**TO ALL EXEC 162F OWNERS with  
ACIS EQUIPPED ENGINES**

**ADVISORY BULLETIN A-41**

Subject: ACIS - Altitude Compensation Induction System

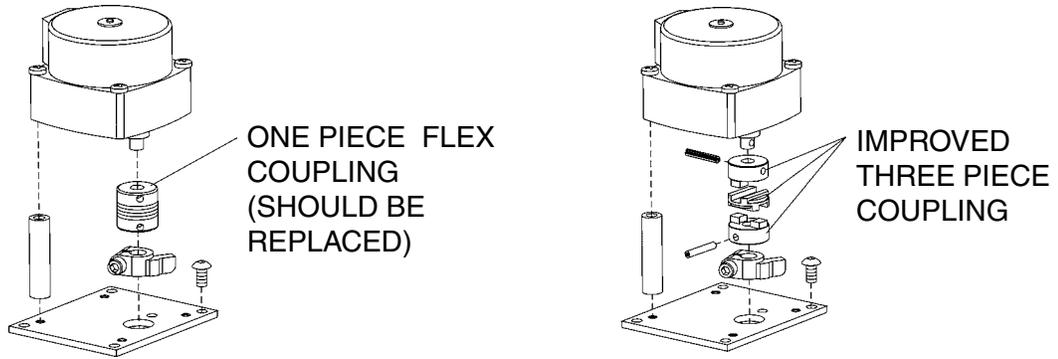
- 2. The flexible coupling for the stepper motor control, used on earlier systems, should be replaced with the improved coupling. See illustration below. Use the Stepper Motor Coupling Kit, part number E38-5200.
